Modification to run CPU09CMI on 3MHz bus.

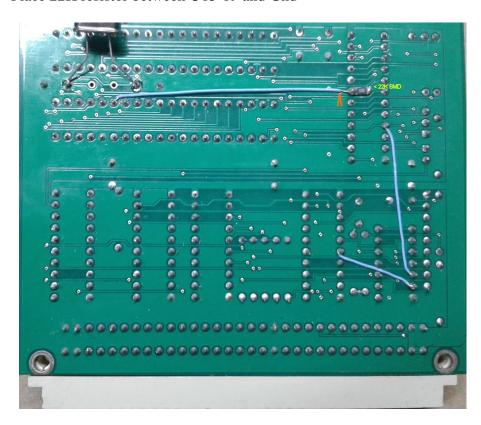
Replace xtal into 12MHz Replace GAL CMI_1 by CMI-4_1

On solder side:

Cut trace between U13-19 and via (OVMA) Place 22K resistor between U13-19 and Gnd

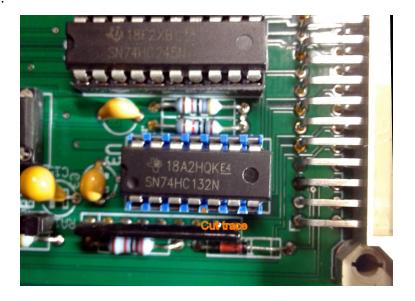
To keep CPUxxCMI 6802 compatible:

On top side:

Cut trace between U3-4 and U3-5

On solder side:

Place wire from U3-5 to U13-9 Place wire from U3-6 to U4-6
